PROJECT: Gilcrease Nature Sanctuary

| <b>SUBJECT:</b>                                                       | Drainage Study for:<br><b>Gilcrease Nature Sanctuary</b> | <b>COPIES TO:</b><br>Hauntec                                                                      |

Subject: Addendum to the Technical Drainage Study for Gilcrease Nature Sanctuary  
(SDR-43981; ZON-43982 & GPA-43983)  
(APN 125-09-401-033) (DS4541)

| <b>JOB NO.</b><br>11-0004                                                                                                    | <b>SHEET NO.</b><br>C1<br>1 OF 2                                                                     |

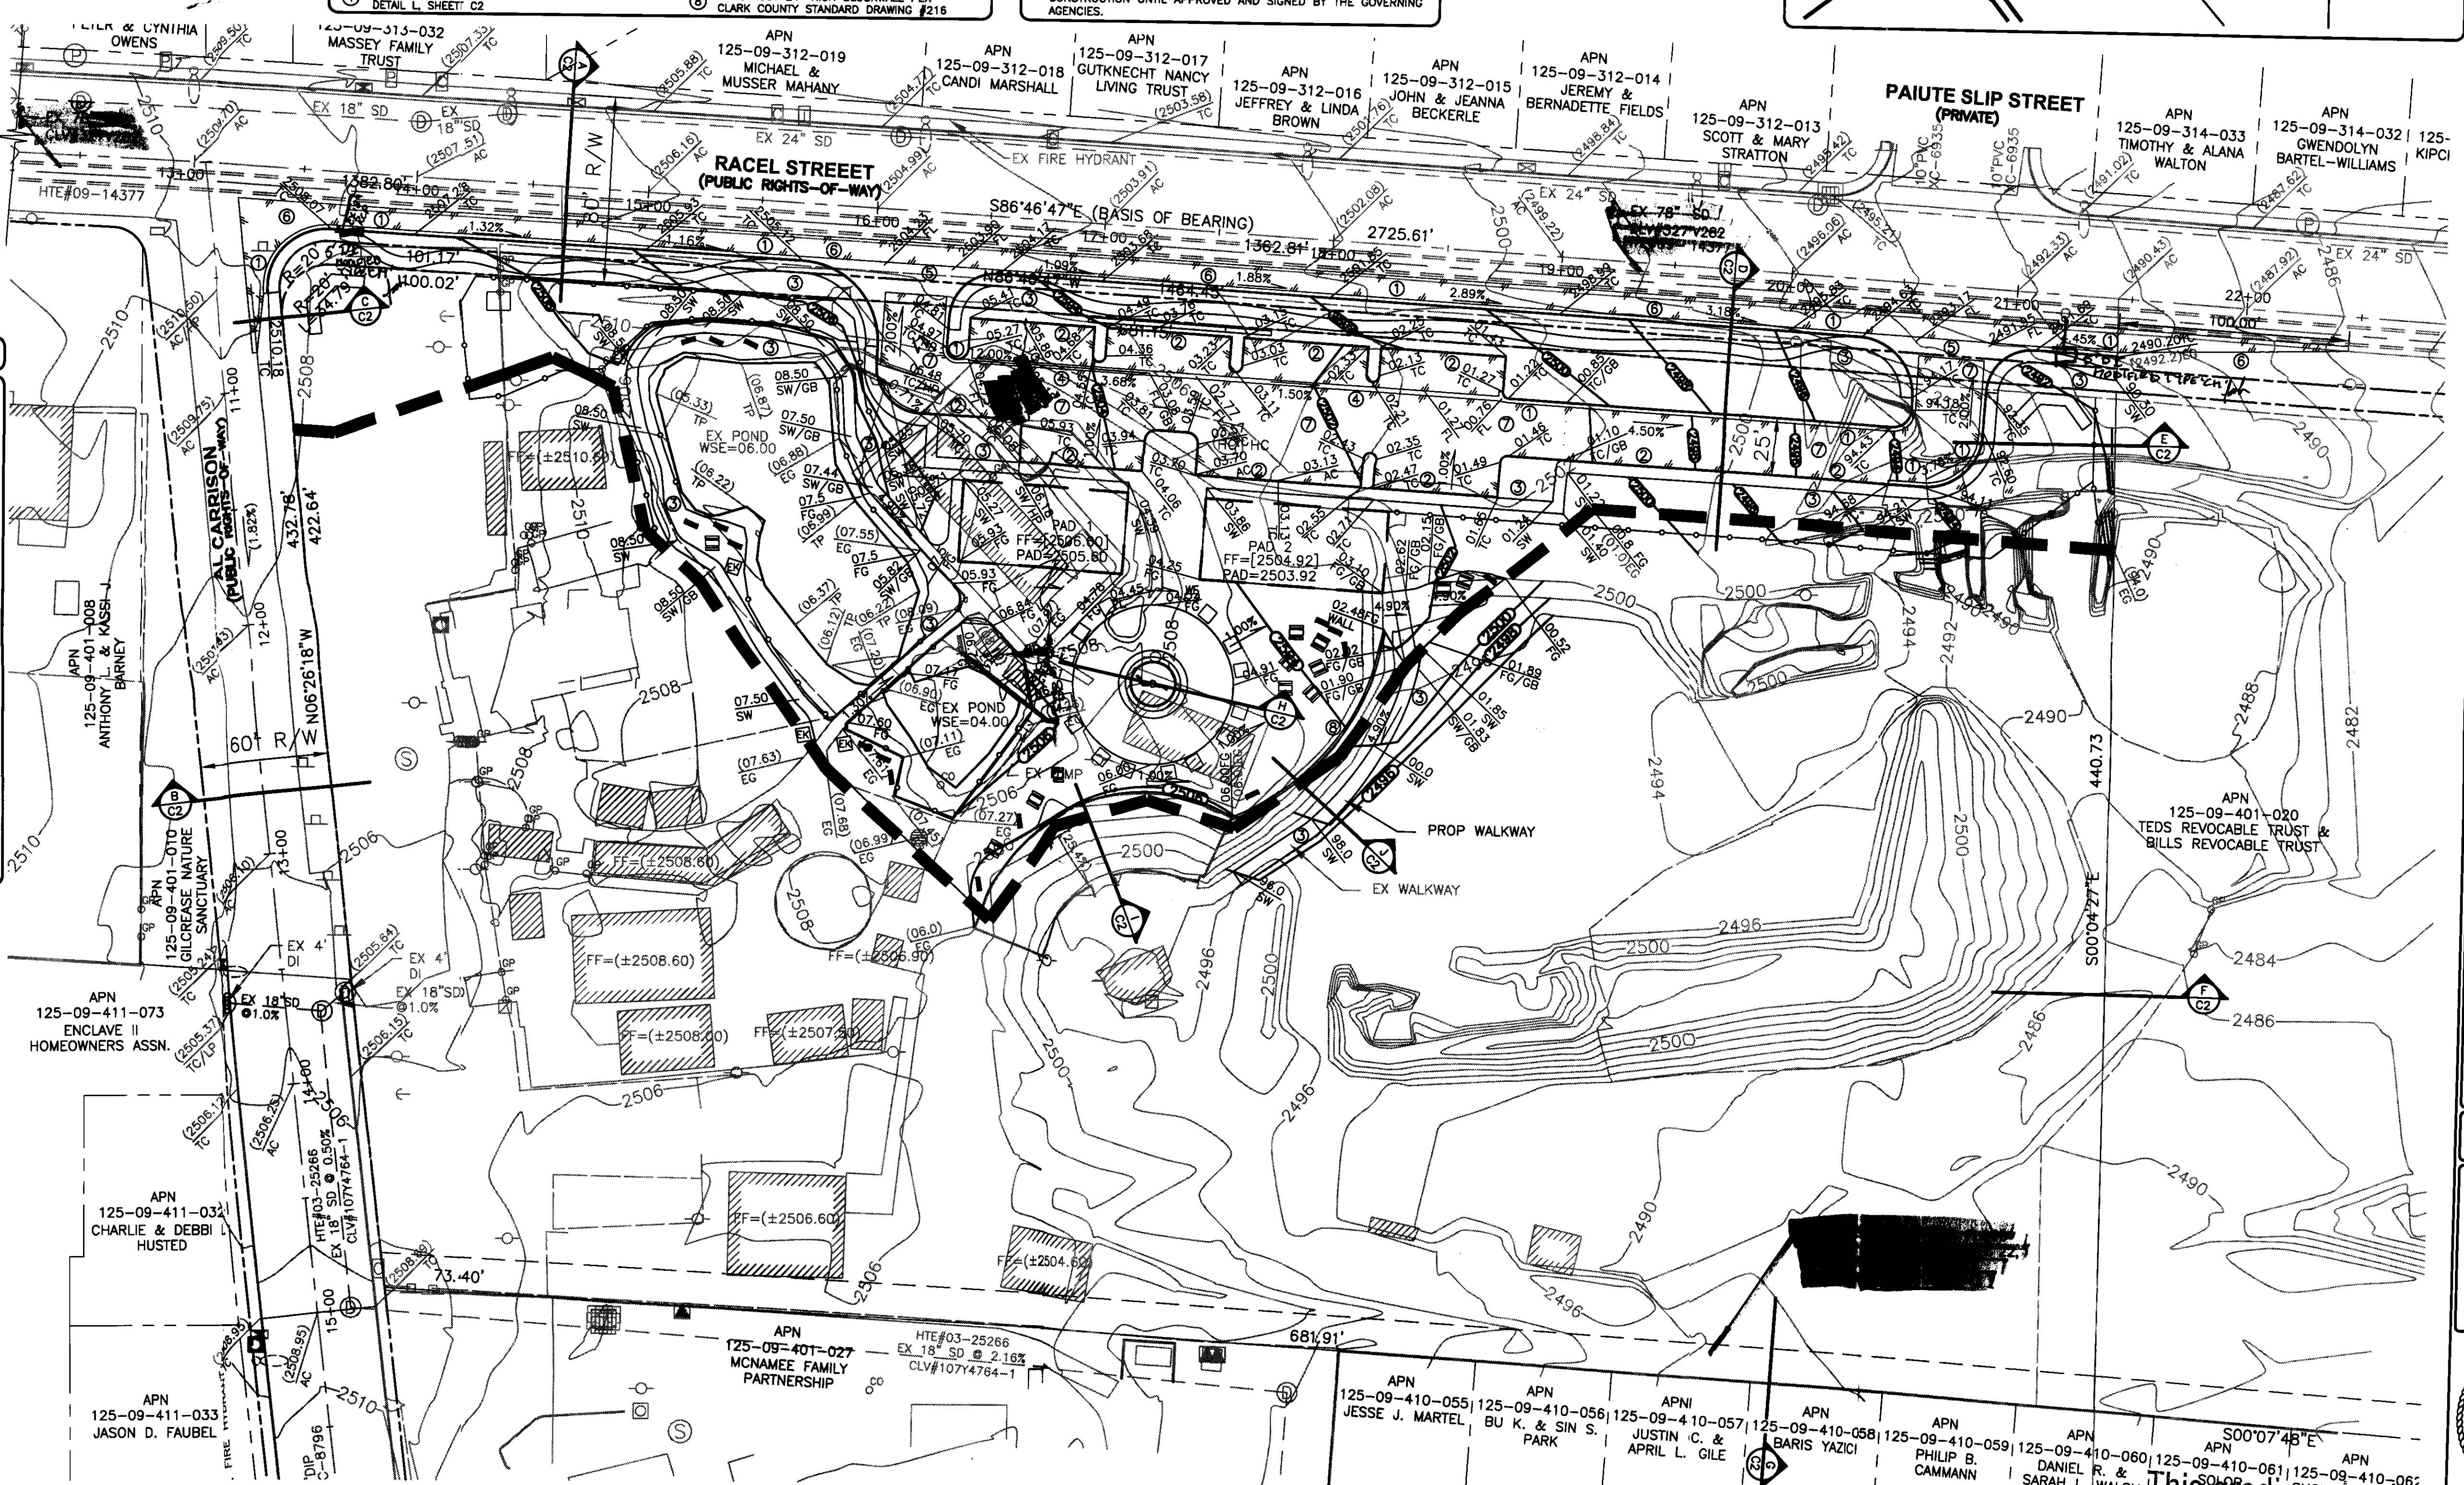
4. It appears that a hump is proposed in the west driveway in Racel Street for onsite protection from a major storm event. The anticipated 100-year flow depth in Racel Street

is 0.70'. Per the proposed high point elevations show on the grading plan, the hump is not high enough to provide for a minimum of six (6) inches freeboard above the 100-year water surface in the street. Review and revise the high point elevations accordingly.

5. Identify an existing 15'-wide easement for flood control along the southern border of the subject property. Label easement with the recorded document number on the grading plan.

6. Identify an existing Clark County Regional Flood Control facility (78" RCP) in Racel Street. Label with recorded construction document number on the grading plan.

7. Identify an existing storm drain system in Al Carrison Avenue. Label the size and type of the associated drop inlets and storm drains with the City of Las Vegas recorded drawing number on the grading plan.

8. Show the existing residential development to the north of Racel Street on the grading plan.

**Response: The driveway design grades have been revised to provide an adequate hump of a minimum of 6-inches of freeboard above the 100-year water surface in Racel Street.**

**Response: The grading plan has been revised to the show the 15ft-wide drainage easement along with the recorded document number. (See attached)**

**Response: The grading plan has been revised to the show the Clark County Regional Flood Control facility (78" RCP) in Racel Street along with the recorded construction document number. (See attached)**

**Response: The grading plan has been revised to the show the existing storm drain system in Al Carrison Avenue along with the City of Las Vegas recorded drawing number. (See attached)**

**Response: The grading plan has been revised to the show the existing residential development to the north of Racel Street. (See attached)**

SHEET NO.  
02

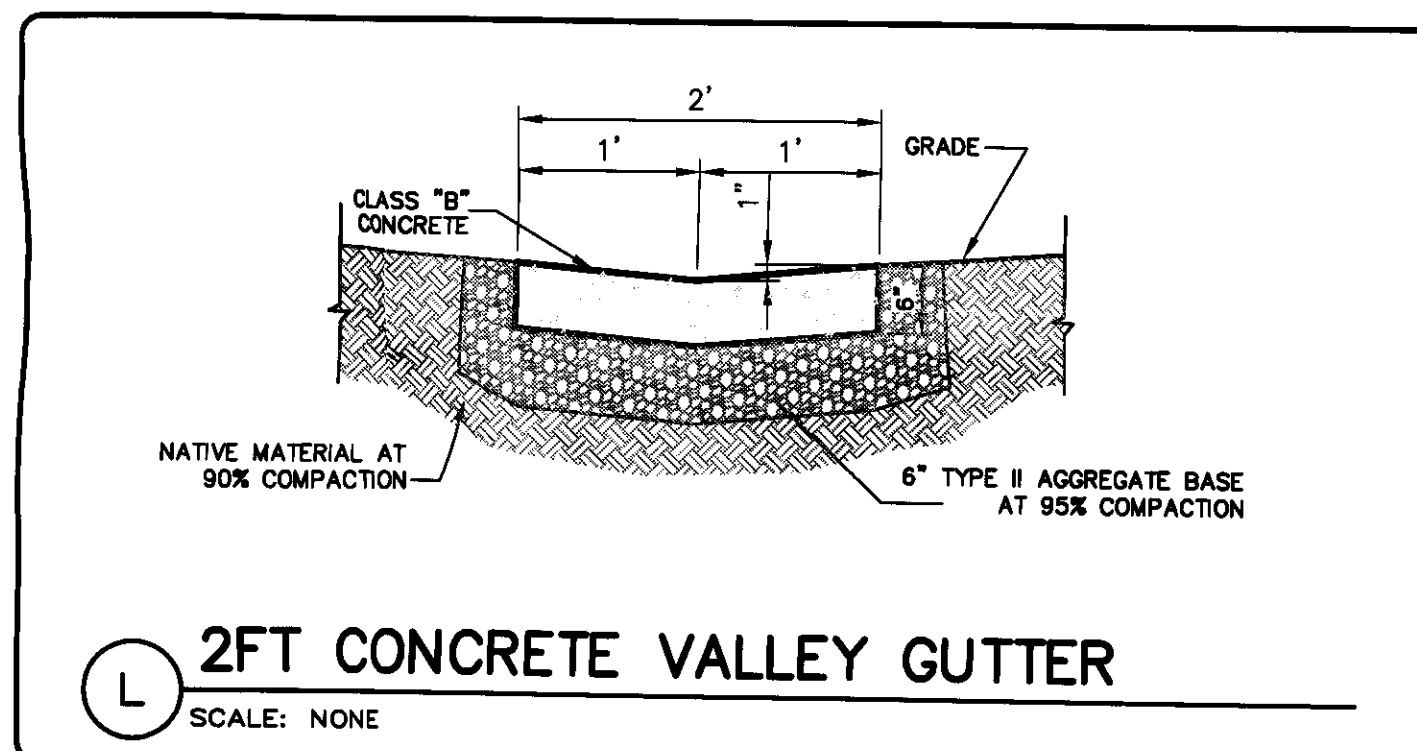
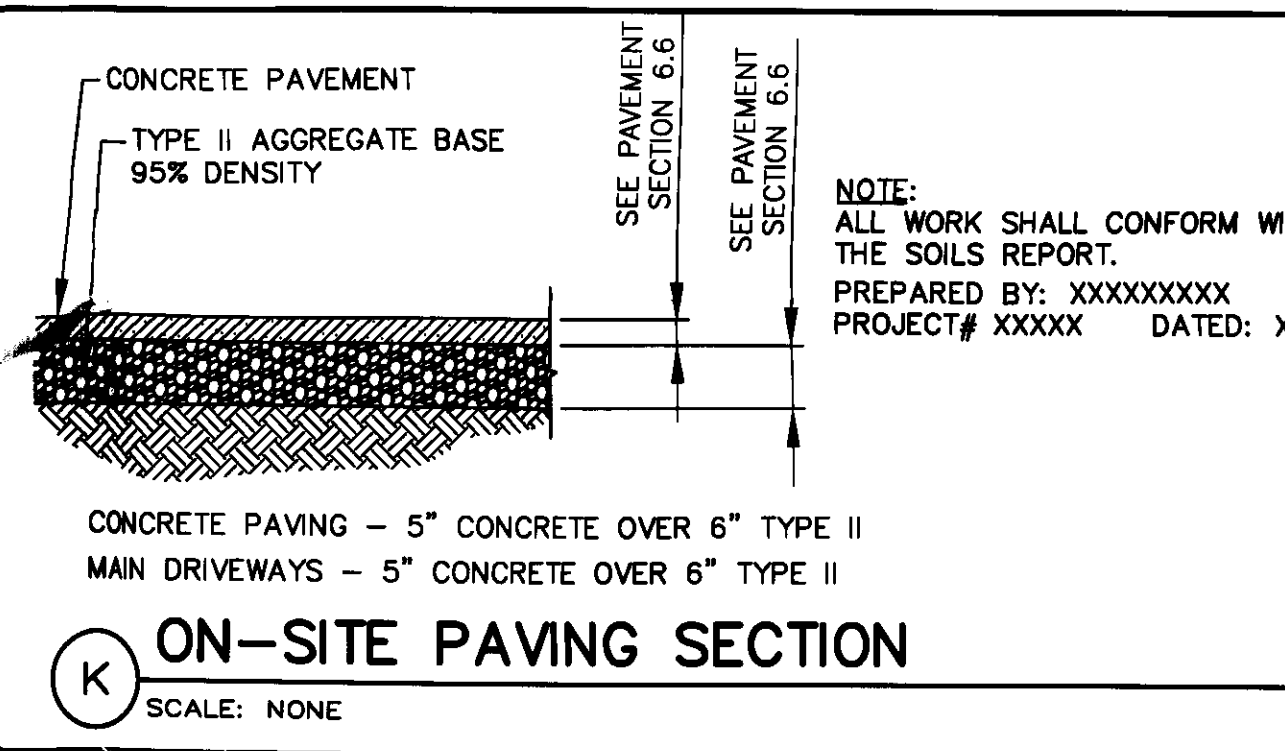
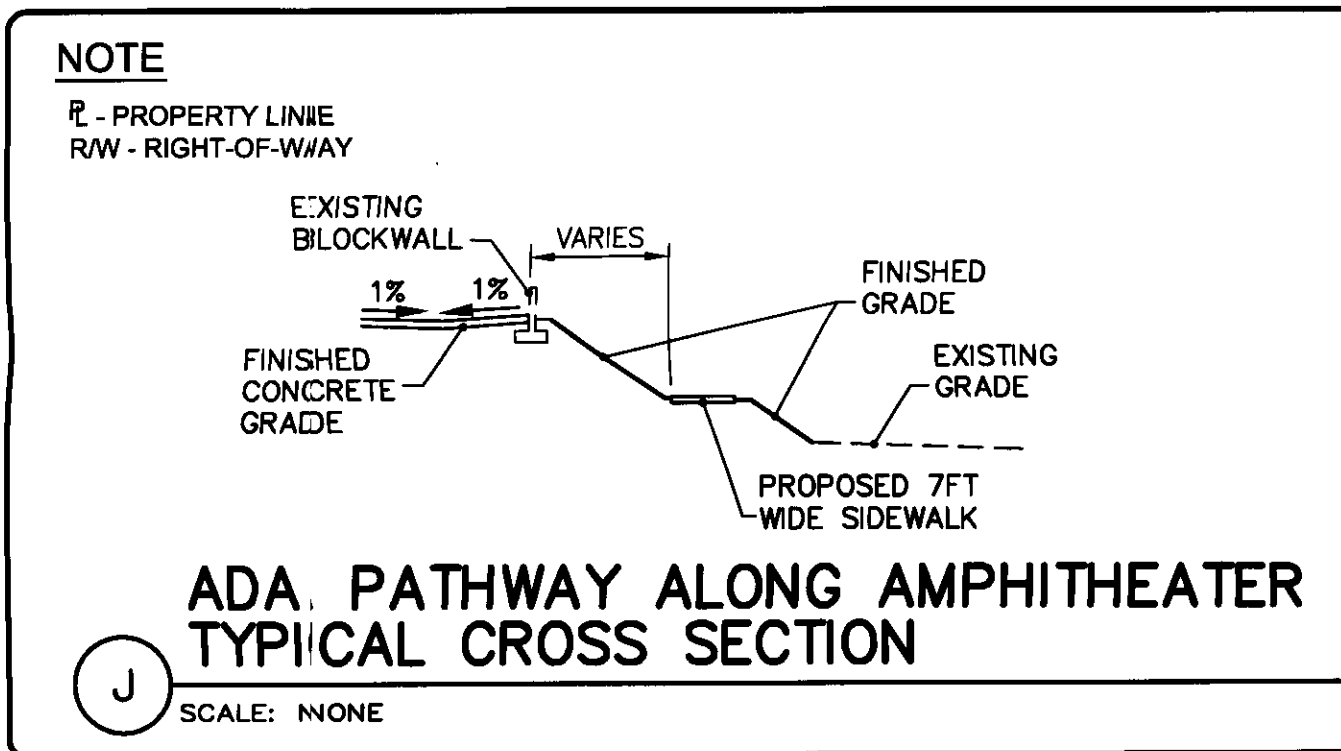
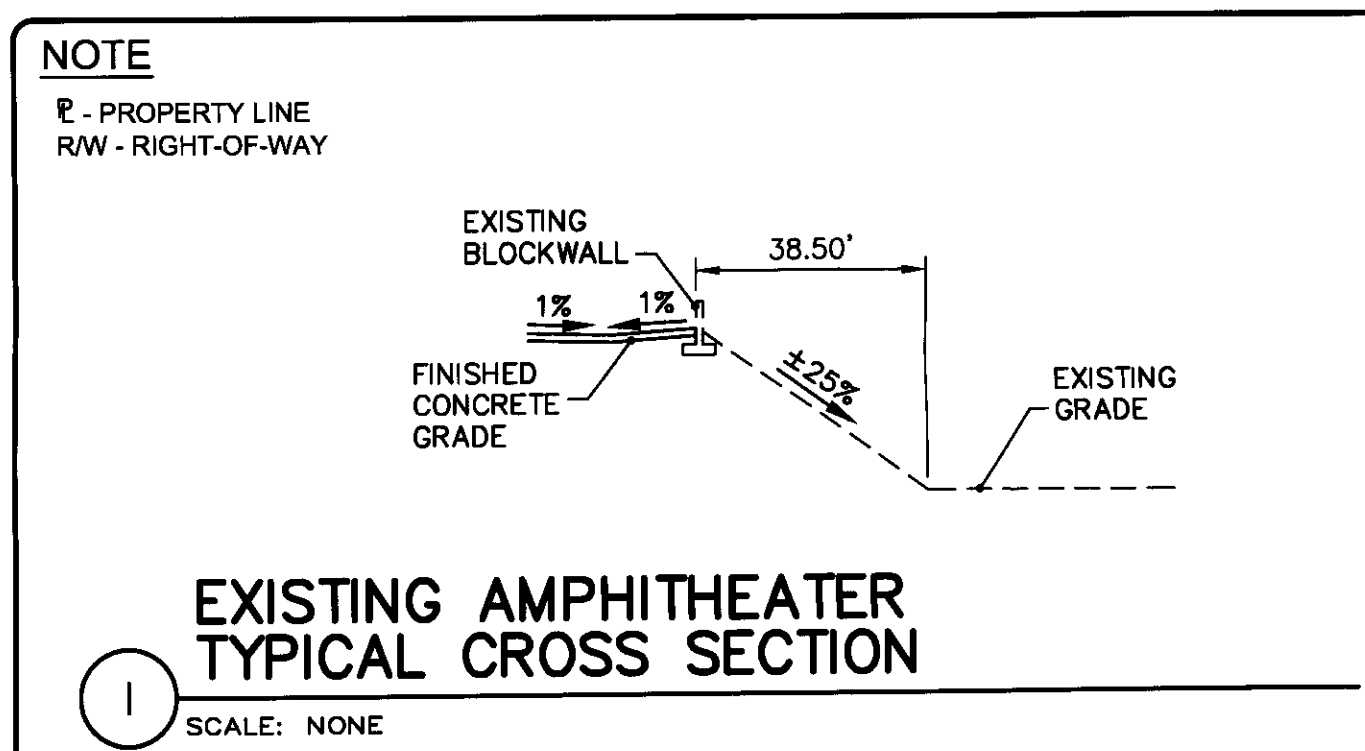
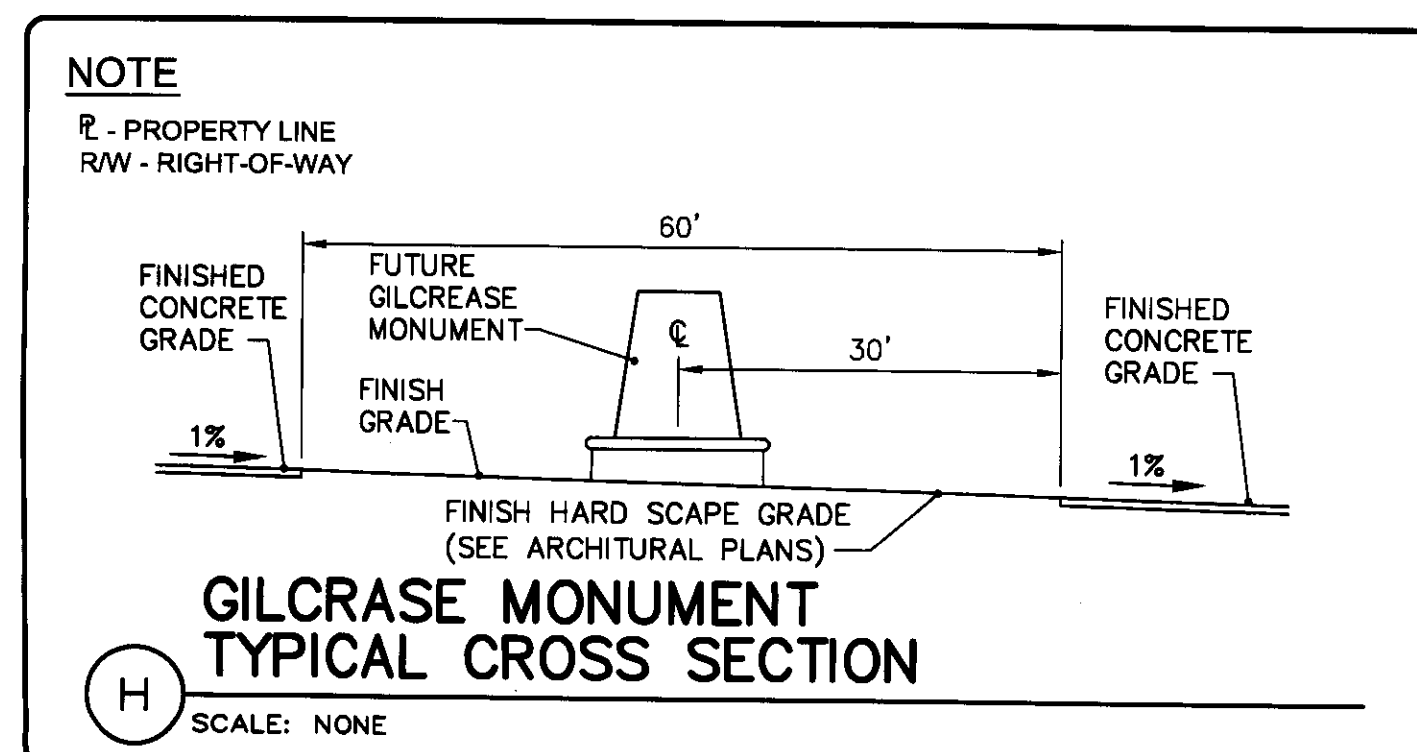
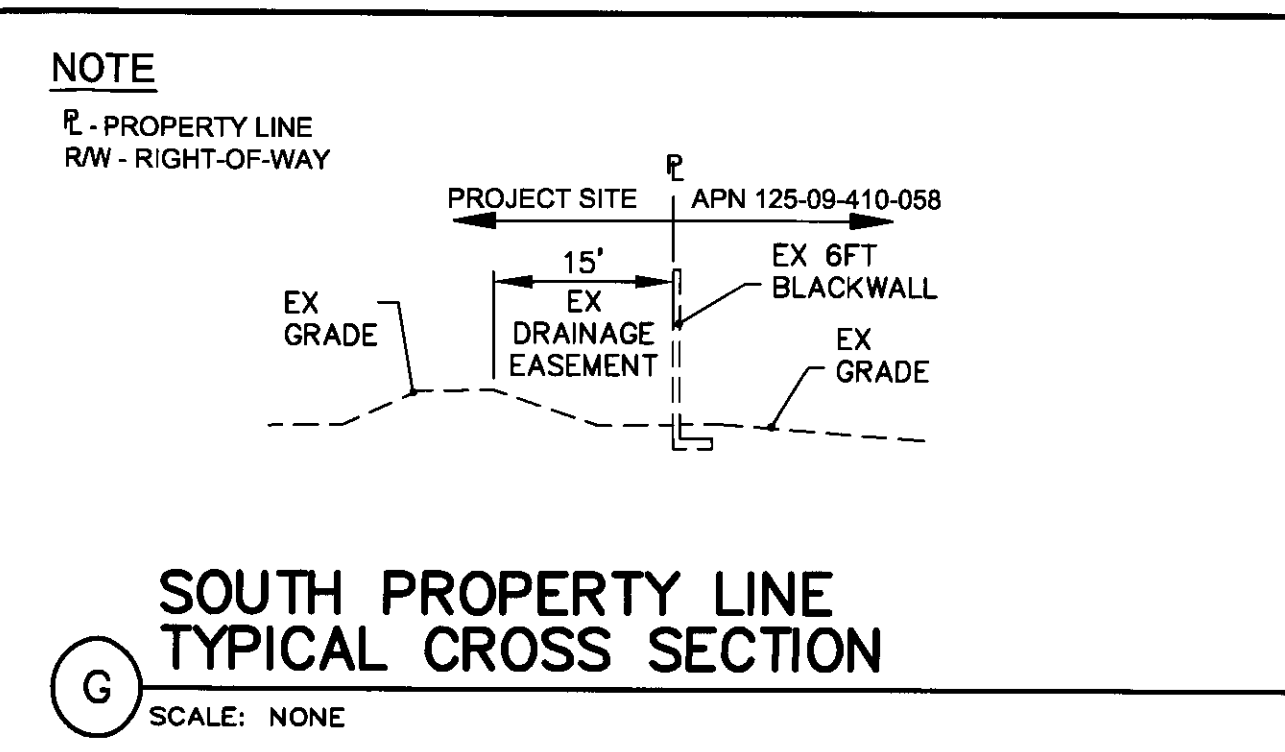
9. **Section A/C2:** Show proposed curb & gutter and sidewalk in section detail.

10. **Section D/C2:** Revise the 30' width to 40' between the centerline of the street and the right-of-way line.

**Response: The section has been revised. (See attached)**

**Response: The section has been revised. (See attached)**
